Range <b>SLIF</b>	Model <b>C2100 – C3100</b>	T.I. Nr <b>03_2012</b>
Serial Number <b>14911292</b>	Subject <b><u>TRIP wave 1</u></b>	Complaint Nr <b>N/A</b>

**PLASTIC PARTS CHANGED**

The assembly boiler ( SPARE **31213500S** ) have been modified as detailed below.

### ASSEMBLY BOILER

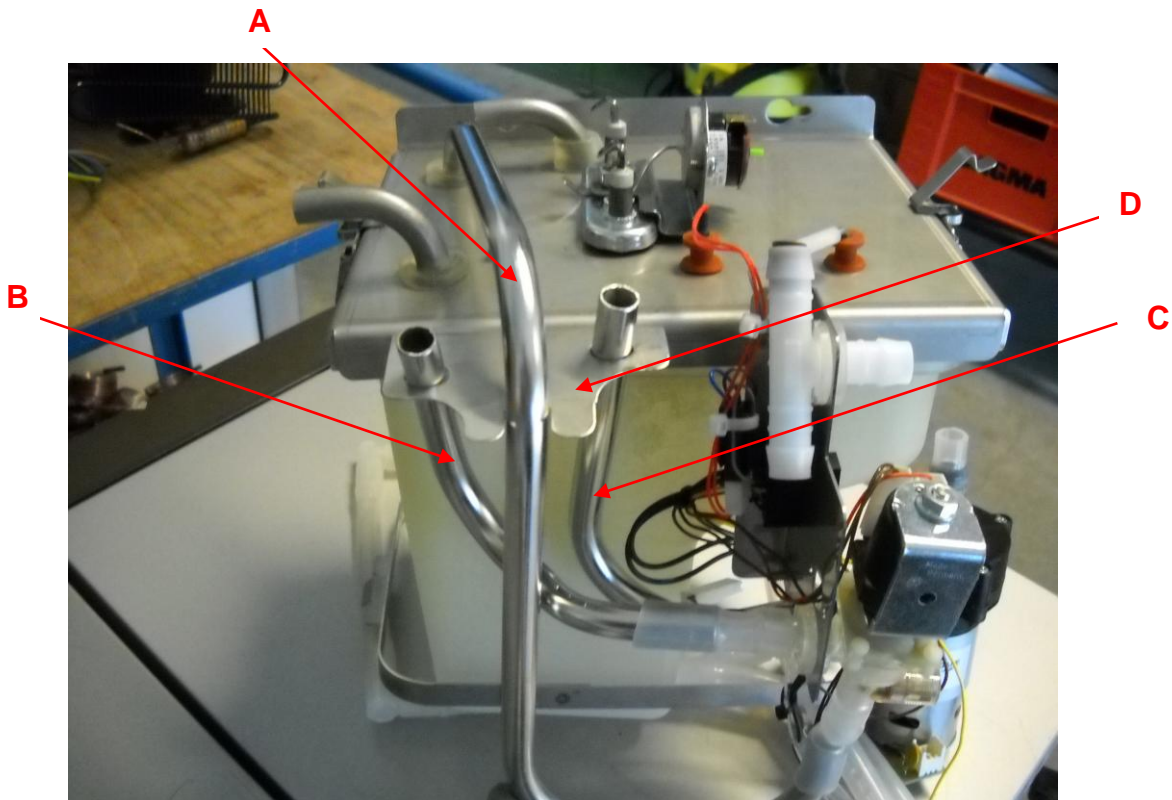
In order to improve the water flow, the material of boiler pipes has been changed from silicon to stainless steel.

- A) *OLD* silicon pipe ( SPARE **255541** )      *NEW* stainless steel tube ( SPARE **256787** )
- B) *OLD* silicon pipe ( SPARE **255541** )      *NEW* stainless steel tube ( SPARE **256788** )
- C) *OLD* silicon pipe ( SPARE **255541** )      *NEW* stainless steel tube ( SPARE **256789** )
- D) boiler cover with bracket ( SPARE **256790** )

The complete modification kit to assembly machines in the field and in stock is **256896** and include:

- ✓ Stainless steel tubing;
- ✓ Silicon hoses Ø 9 – ø 13 mm. in the water system (long enough to cover FB 7300 model as well);
- ✓ Spacer between the boiler and side wall of cabinet;
- ✓ Metal spring(s) around silicon hoses where applied;
- ✓ Clamps for tightening silicon hoses on “difficult” connections to T-pieces;
- ✓ Gaskets in the boiler lid and the gasket between boiler and lid;

### DRAINING PROCEDURE

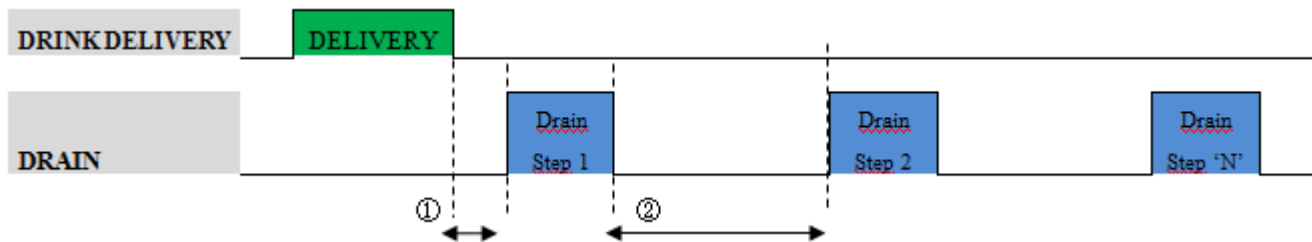
Draining procedure is performed:

- After machine start-up;
- After 3 seconds of each drink delivery end;
- Each time the door of the machine is opened and then closed.

Draining procedure is not performed when the door of the machine is opened.

A drink delivery request, performed during draining procedure, has priority.

Draining procedure can be enabled ore disabled by means of menu “*Technician->Adjust System->Improved Drain->Status On/Off*”: as default is set to ON.

Par	Description	Time (seconds)
①	Delta time, in seconds, between ‘drink delivery end’ and ‘start of drain procedure’.	3
②	Delta time, in seconds, between the end of a drain procedure and the start of the next one.	10

### **AVAILABLE PARAMETER IN MENU MACHINE**

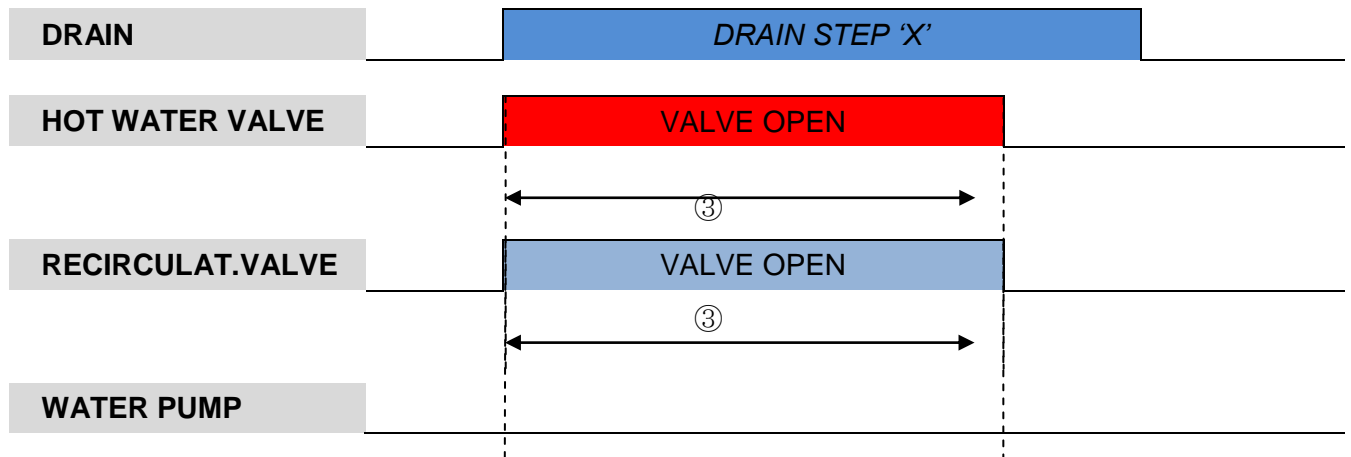
Par	Description	Default Drain Step
<i>Autom.Drains limit</i>	Menu machine “ <i>Technician-&gt;Adjust System-&gt;Improved Drain-&gt;Autom.Drains limit</i> ”. Allows to set the number of DRAIN steps that has to be performed inside a Draining procedure.	50
